MARK	DATE	DESCRIPTIONS	BY	CH'D	CCO#
1	06/23/06	REVISED & NEW PLAN SHEETS ADDED	TH	NV	21

CONTRACT CHANGE ORDER NO. ____
SHEET ____ OF ____

DIST	COUNTY	ROUTE	KILOMETER POST TOTAL PROJECT	SHEET No	TOTAL SHEETS
04	SF	80	13.2/13.9	420RI	1204

FILE => L:\BB\04-0120I\SAS\Contract Plans and CCO\CCO\CCO#21\aaltp01.dgn

TOWER FIELD SPLICE LOCATIONS
1:250

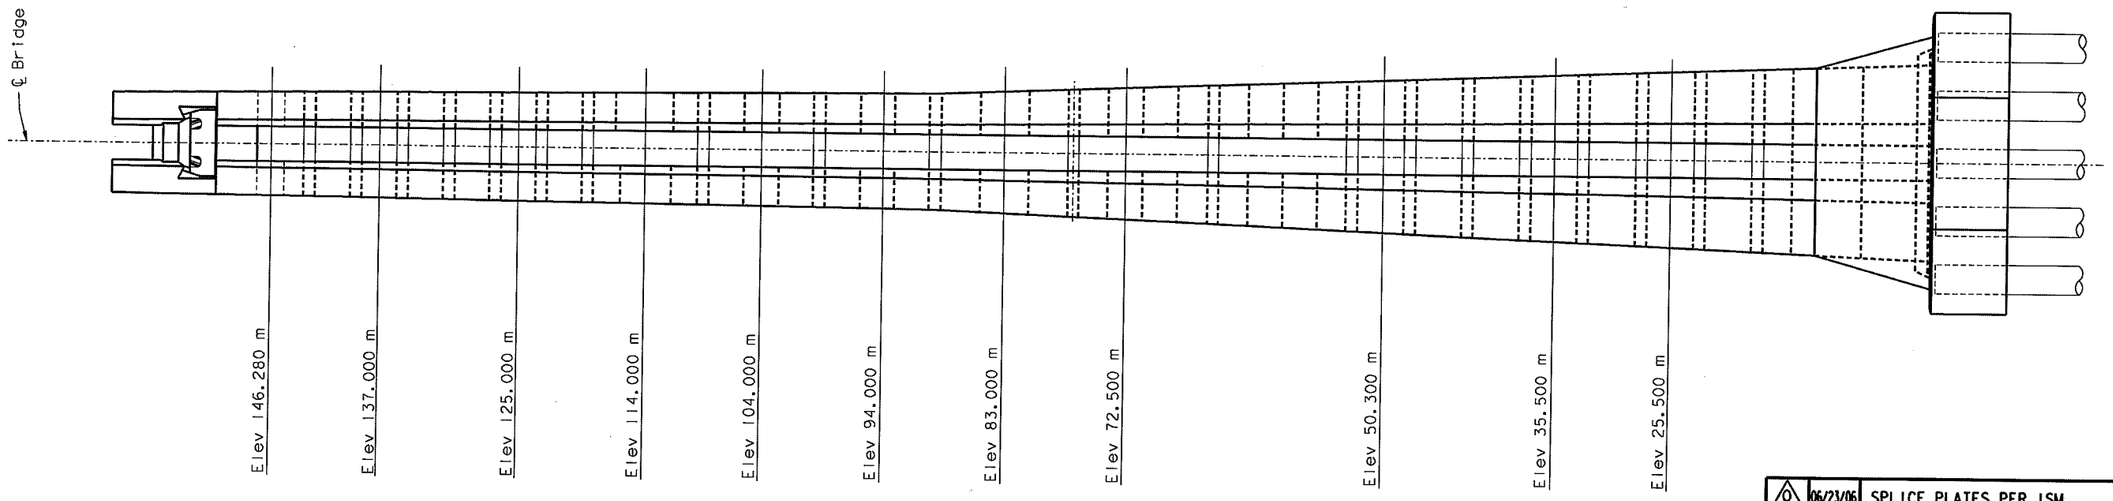
MARK	DATE	DESCRIPTIONS	BY	CH'D	CCO#
0	06/23/06	SPLICE PLATES PER ISM	MN	NV	21

⚠1 ELEVATION A-A
1:15

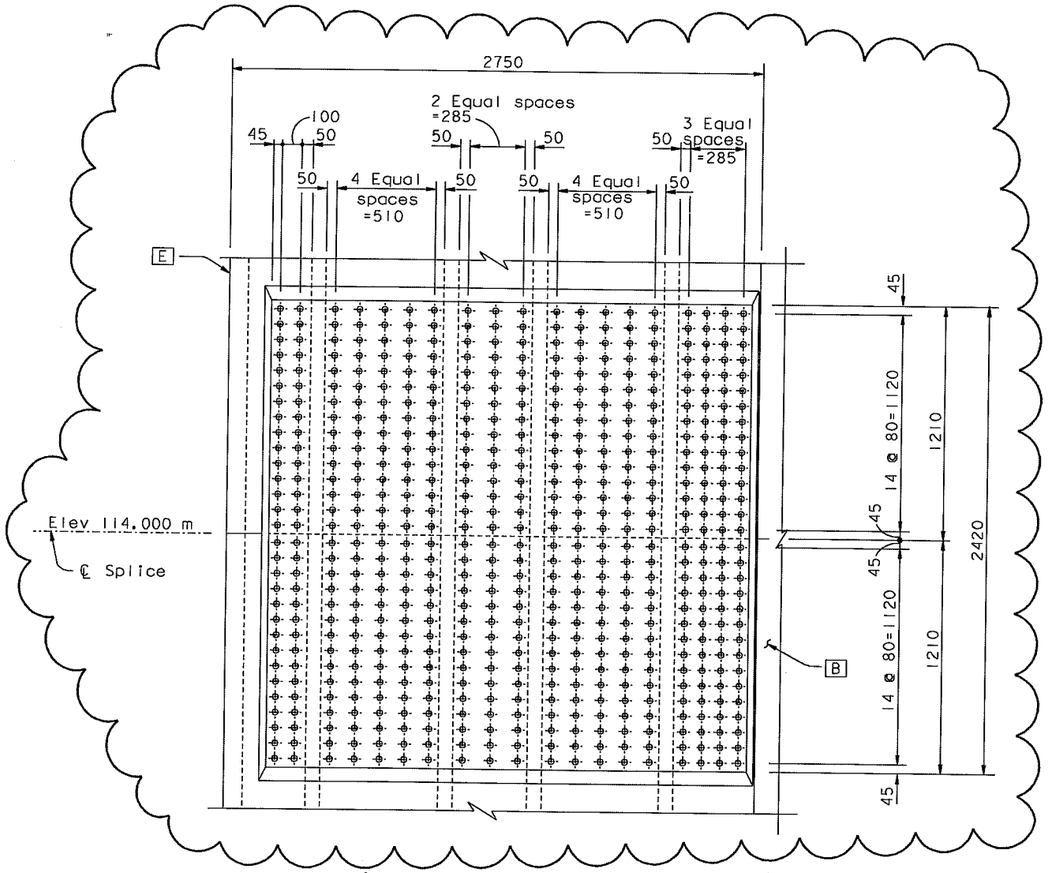
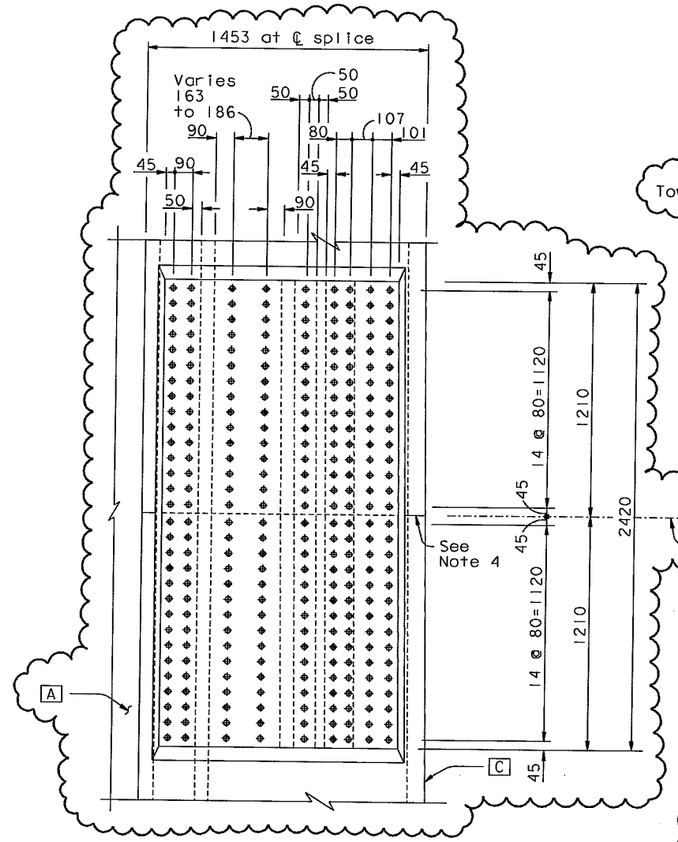
⚠1	06/23/06	SPLICE PLATES PER ISM	MN	NV	21
MARK	DATE	DESCRIPTIONS	BY	CH'D	CCO#
		REVISIONS

DETAIL C
1:10

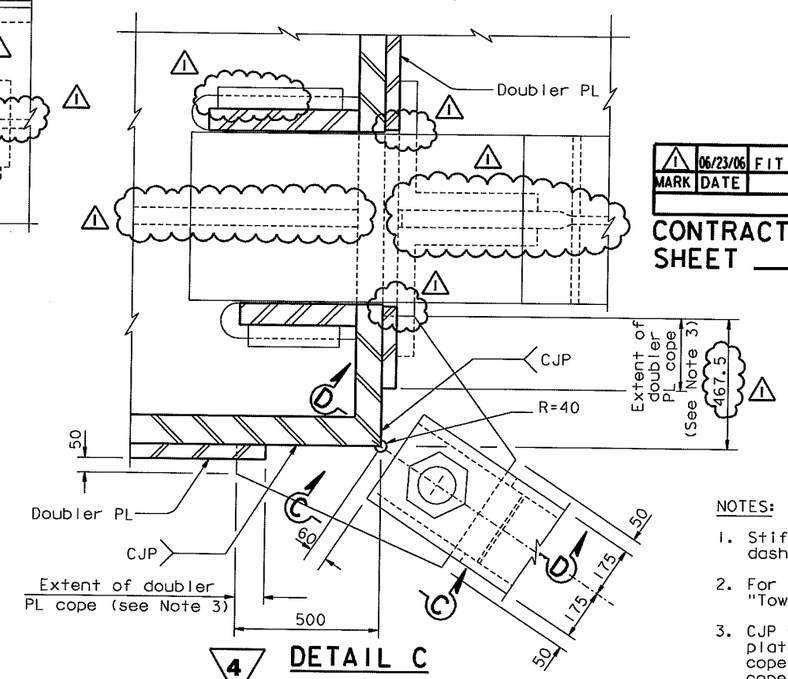
MARK	DATE	DESCRIPTIONS	BY	CH'D	CCO#
1	06/23/06	FIT LUG & MISC.	MN	NV	21

SECTION F-F
1:20

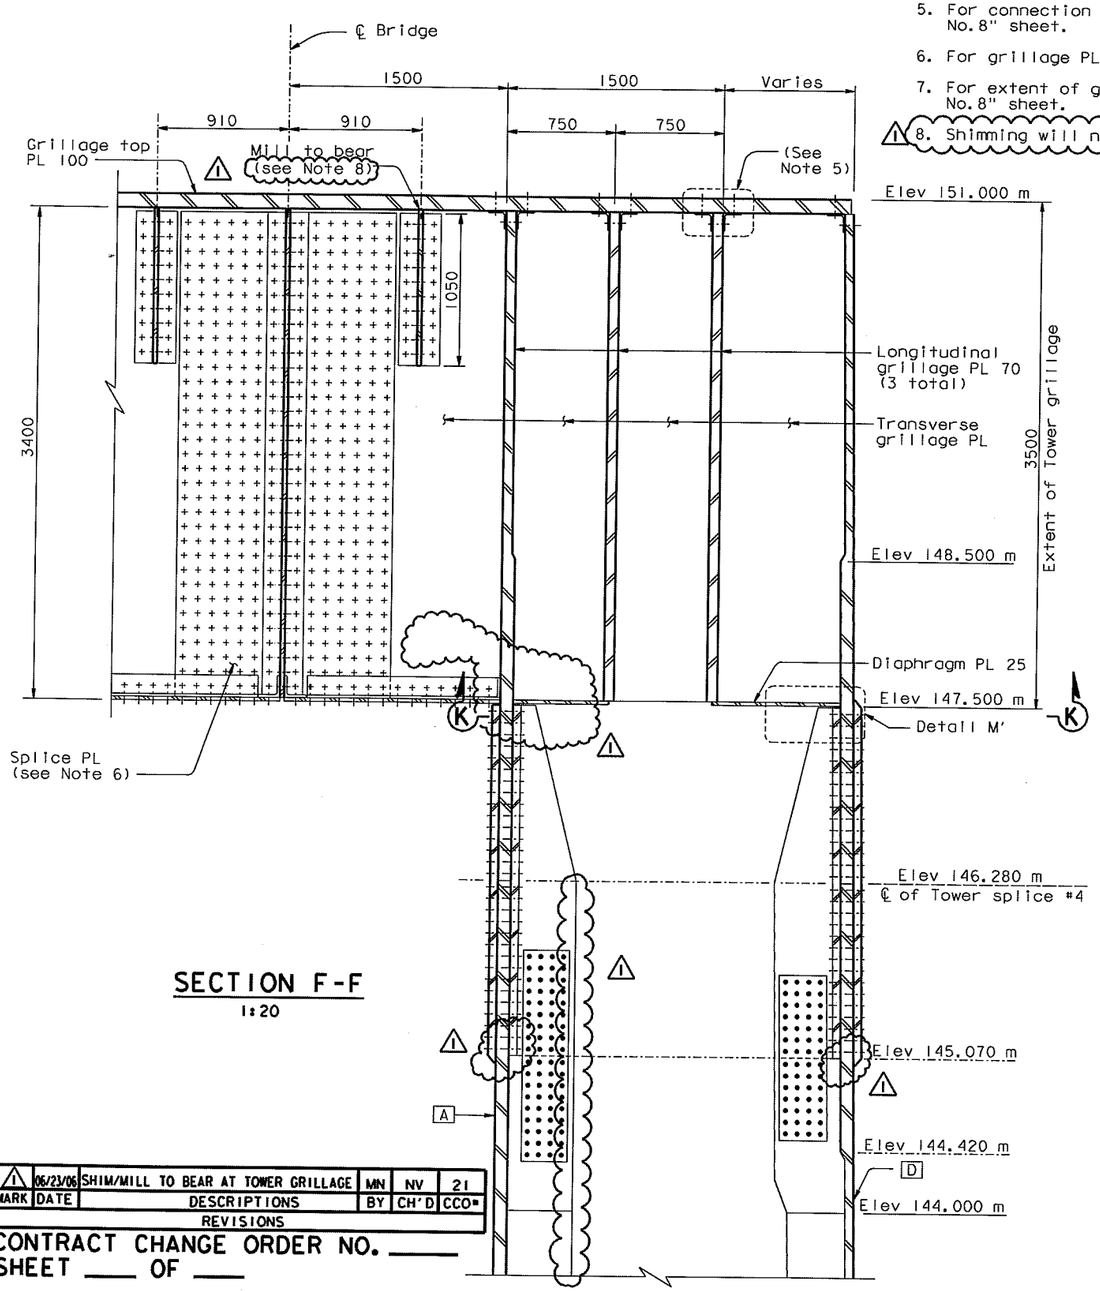
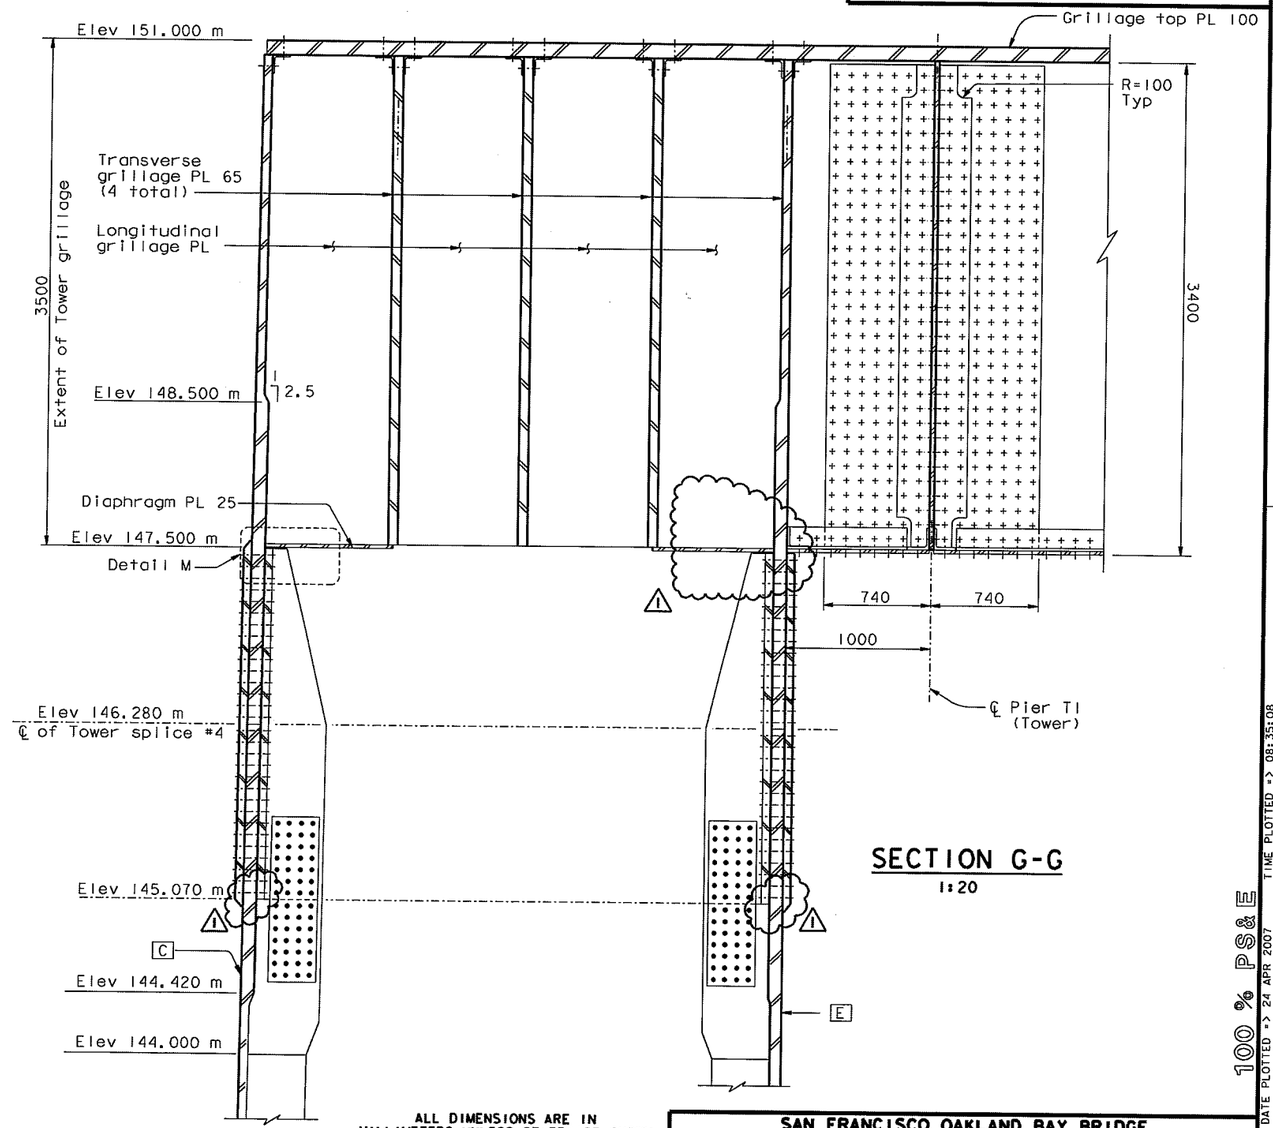
MARK	DATE	DESCRIPTIONS	BY	CH'D	CCO#
1	06/23/06	SHIM/MILL TO BEAR AT TOWER GRILLAGE	MN	NV	21

TYPICAL DIAPHRAGM
SECTION A-A
1:40

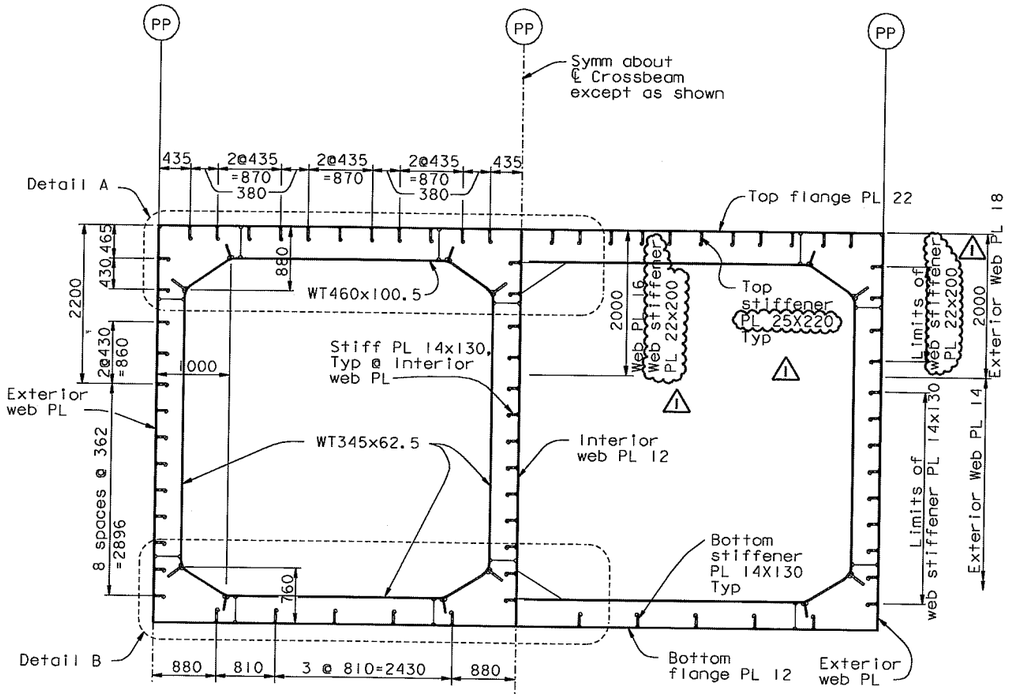
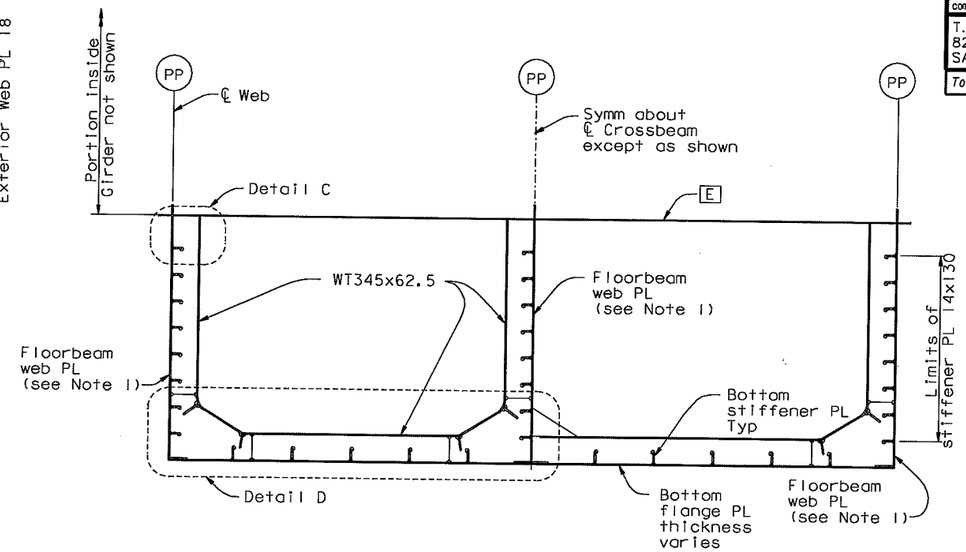
MARK	DATE	DESCRIPTIONS	BY	CH'D	CCO#
1	06/23/06	STIFFENER SIZE INCREASE	GB	NV	21
